August 2021
SF622A
SECOND REVISED NOTICE

Subject: Cascadia/49X ABS MBSP+ Controller Software Update

Models Affected: Specific Model Year 2019-2022 Freightliner Cascadia, and Western Star 49X vehicles, manufactured September 12, 2018, through March 22, 2021.

2ND REVISION: For vehicles with an 8x4 configuration, a note has been added to page 26.

Fig. 33, Choosing the Install Location

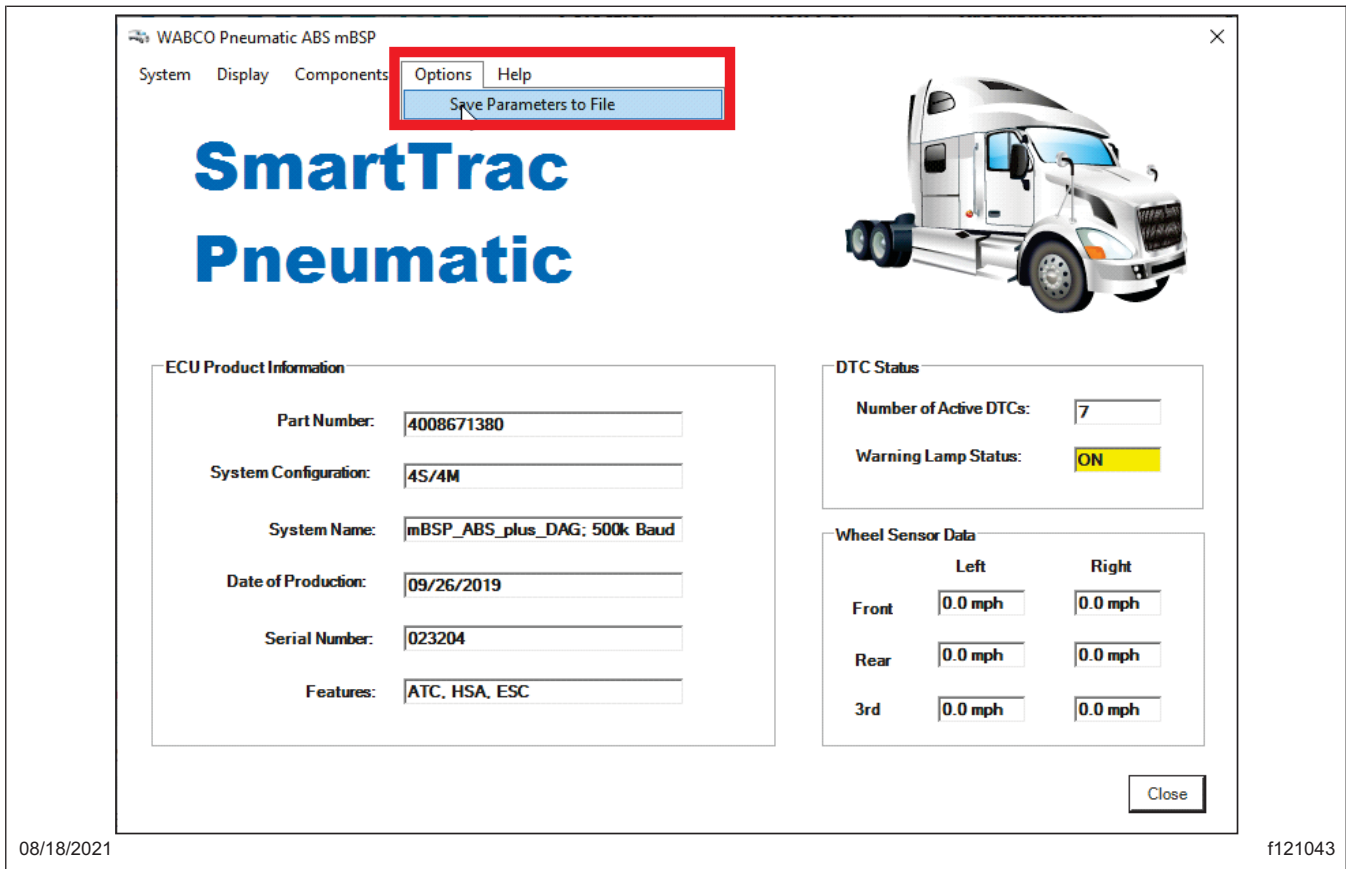
NOTE: Certain vehicles with 8x4 configuration equipped with a pusher axle may not register a fourth axle within the 'Wheel Sensor Data' screen due to vehicle wheel sensor locations, and Wabco Toolbox Plus screen layout. This will not affect the programming, and the parameter update will be completed successfully.
